4TH AVE RESIDENCE

REMODEL & ADDITION

HISTORIC DESIGN REVIEW RE-SUBMITTAL

2017 – 10/30

PROPOSED FRONT ELEVATION - SOUTH
1/8" = 1'-0"

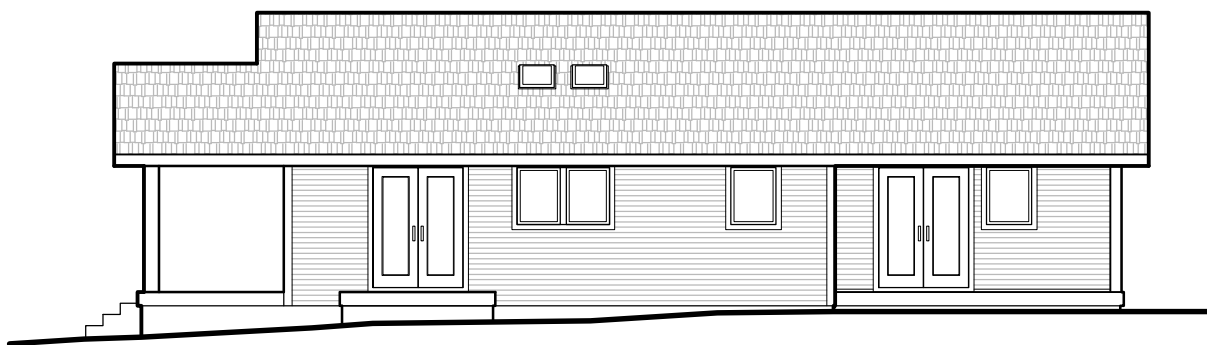
ATTIC VENTS OMITTED AS UNREQUIRED

BUILDING HEIGHT INCREASES APPROX 16-18" FROM ORIGINAL STRUCTURE

01. AS-BUILT / DEMO PLAN
 SCALE: 1/4" = 1'-0"

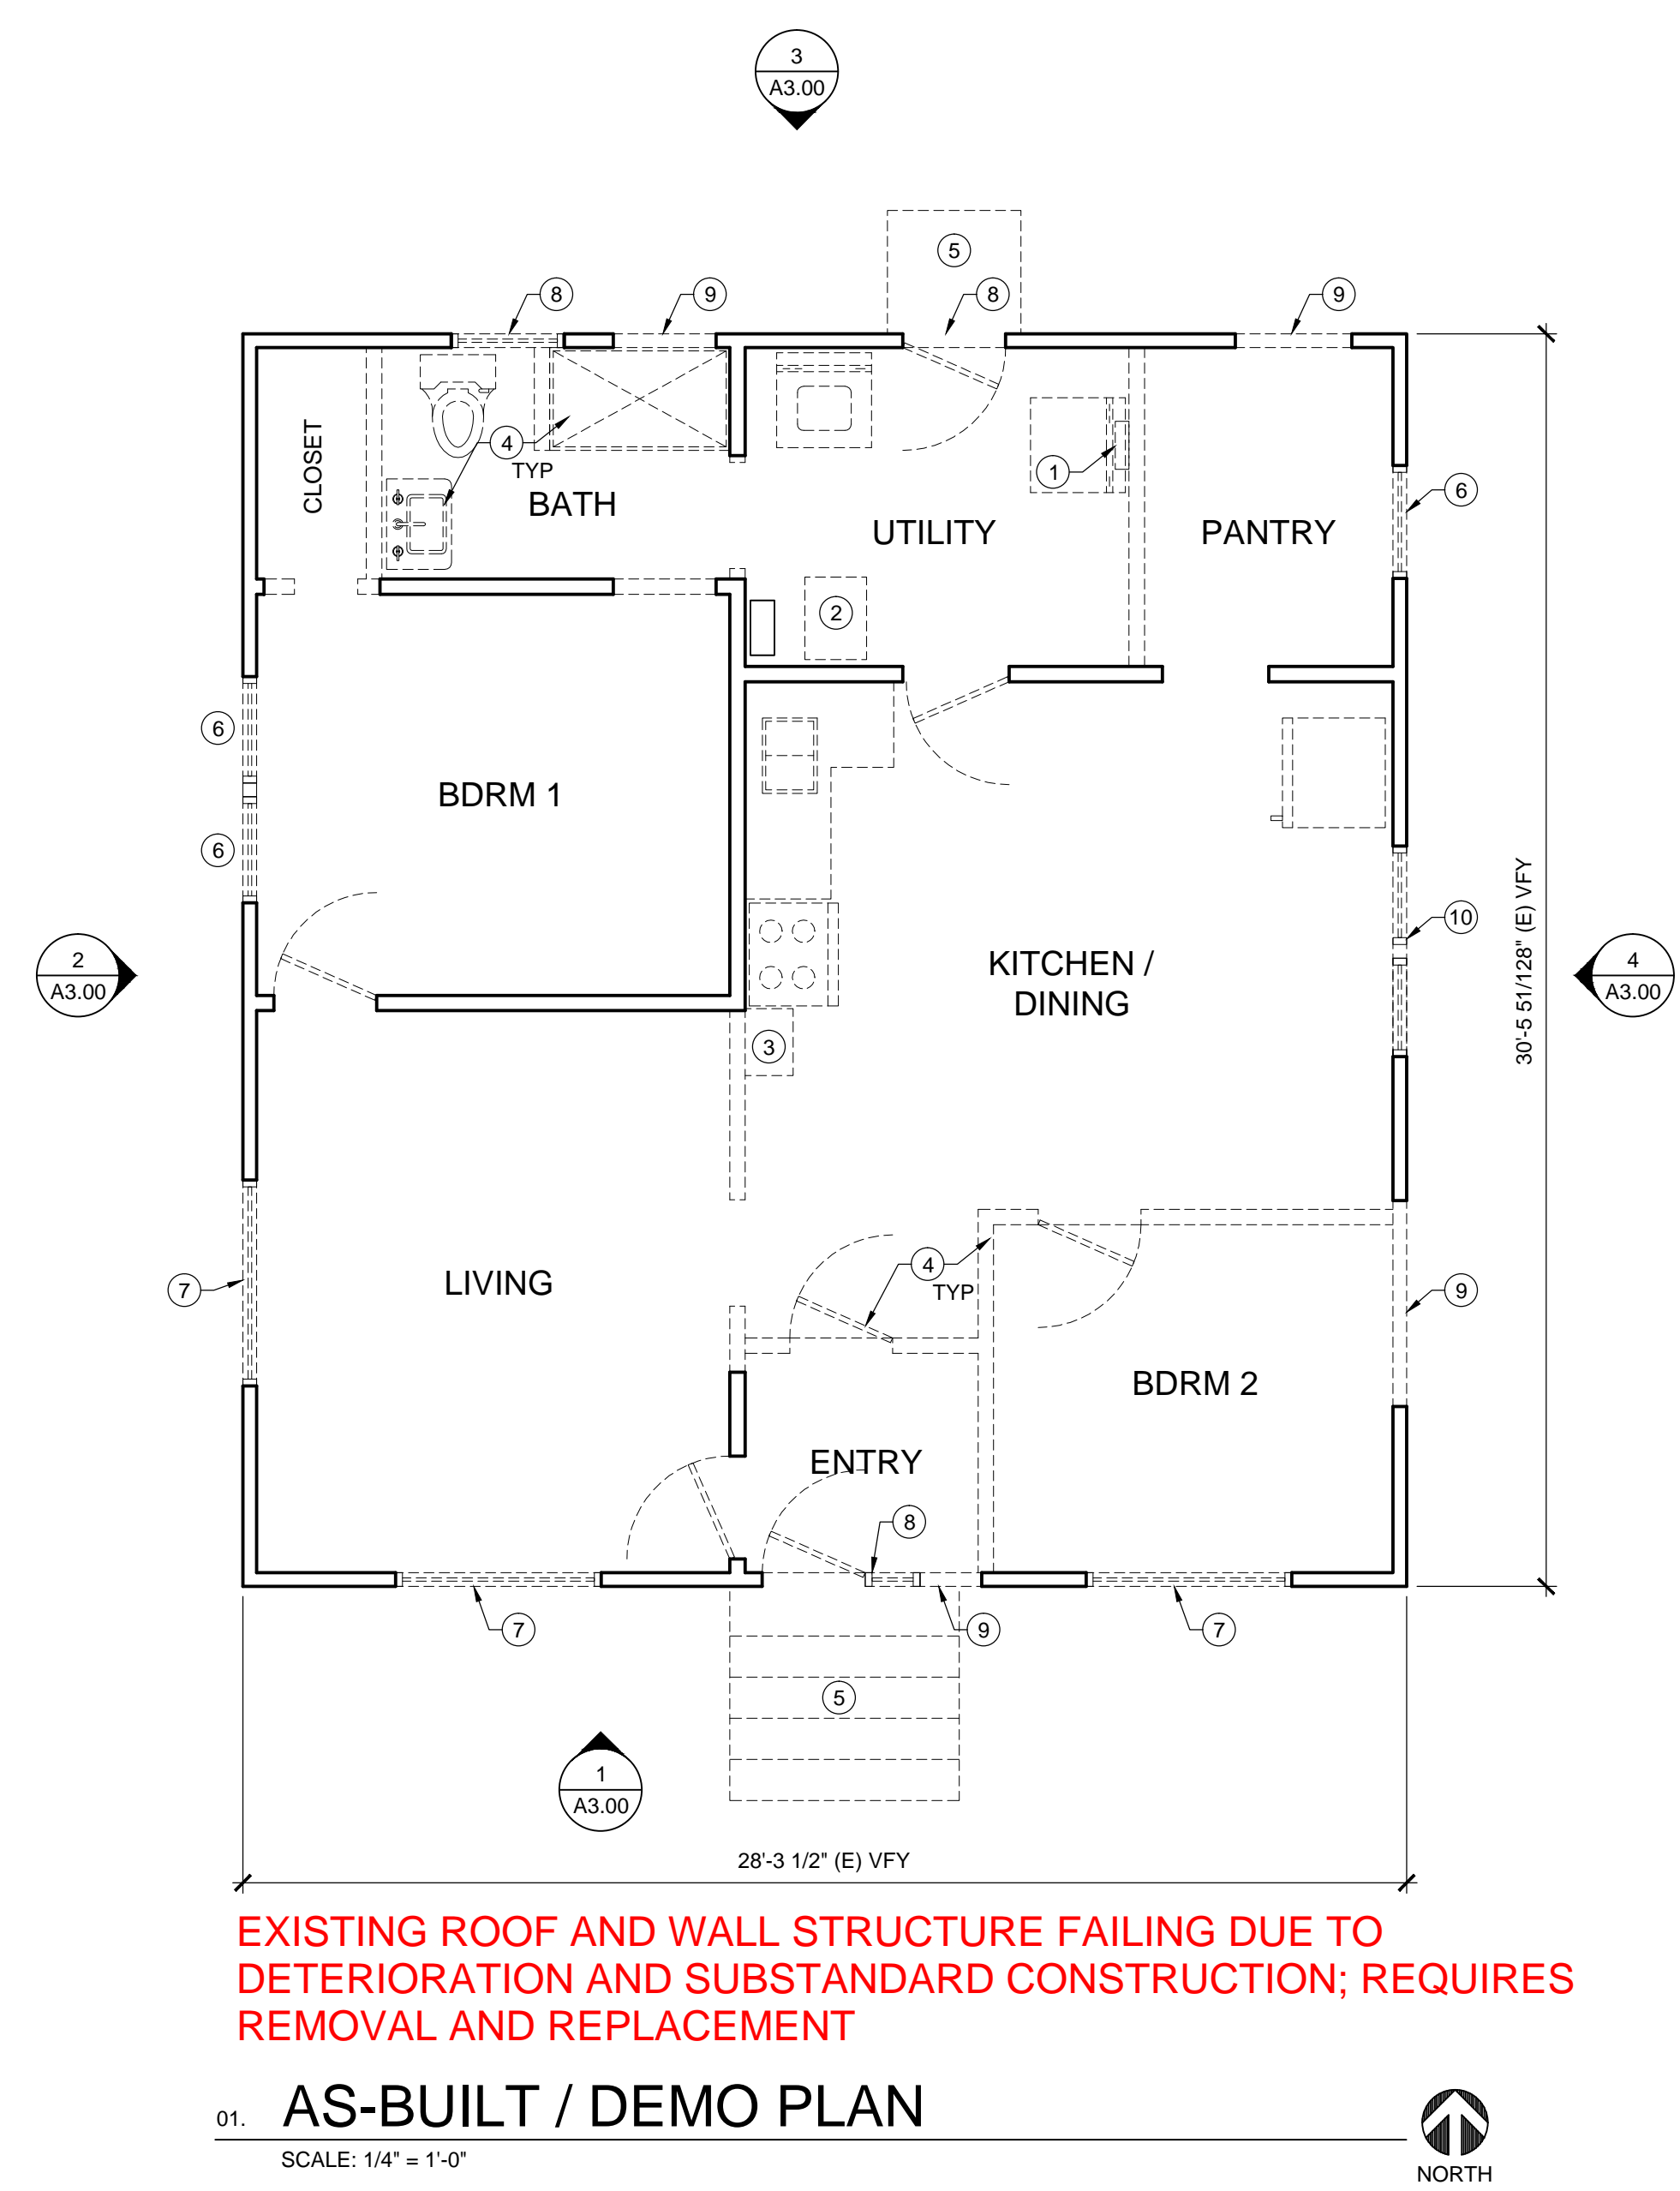
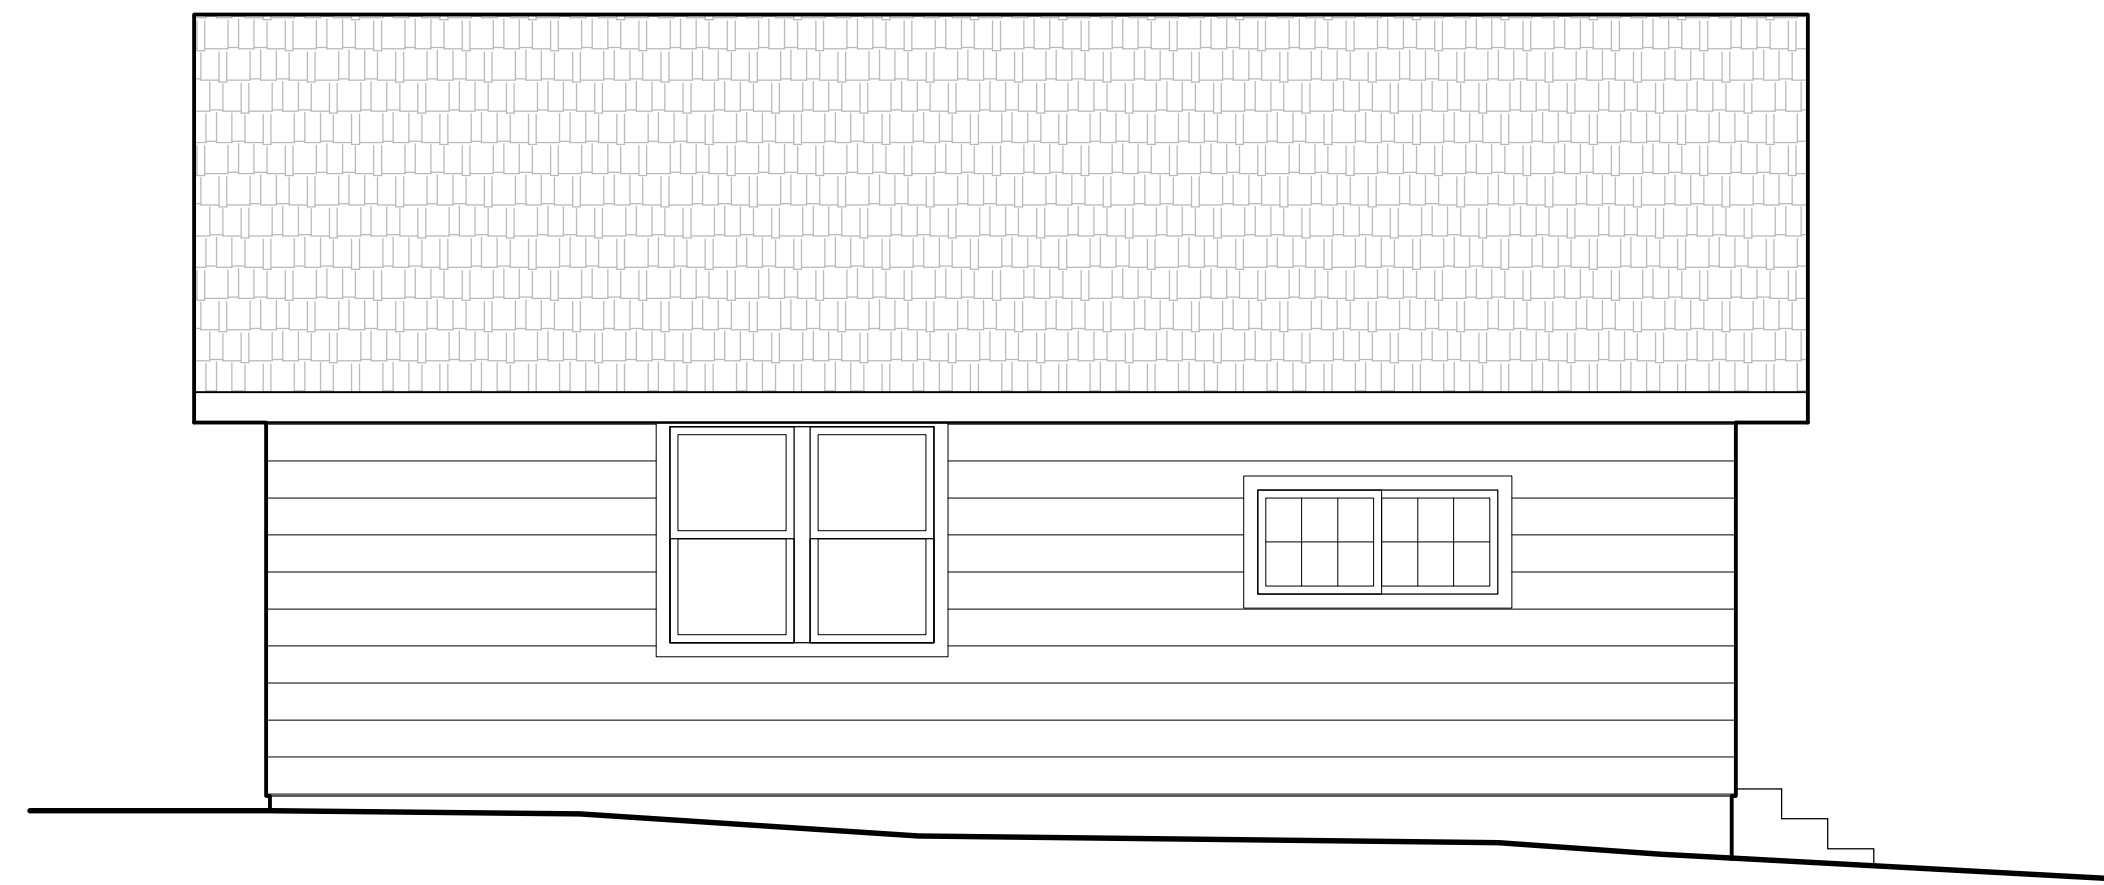
EXISTING ROOF AND WALL STRUCTURE FAILING DUE TO DETERIORATION AND SUBSTANDARD CONSTRUCTION; REQUIRES REMOVAL AND REPLACEMENT
